“IMPORTANT SAFETY RECALL NOTICE”

RECALL NO: 16V-005

Attention Trans Tech Bus Dealer:

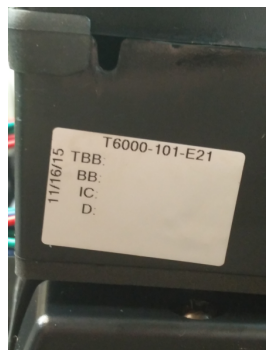
The adhesive and process used to bond the reflective stop decal to the stop arm body/housing was improperly performed, which can lead to delamination and/or detachment during operation. We urge you to bring this vehicle in for servicing on its non-compliant components as soon as possible.

Inspection for this recall may be performed by viewing the underside of the stop arm (pictured below) and reviewing the information printed on the white label (which includes date of manufacture and model).

If your Stop Arm model is any of the T6000-, T6100-, or T7000- and manufacture dates are in the period between May 1, 2015 and Oct 19, 2015, then you are affected.

Replacing the stop arm blade assemblies will resolve the defect (application of the decal to the blade in the field is not recommended). The free service kit provided by SMI will include (1) Transpec stop arm blade (replacement part will be based on the stop arm part number,) and detailed work instructions. It is the responsibility of the end-user to inspect for and mitigate the remedy.
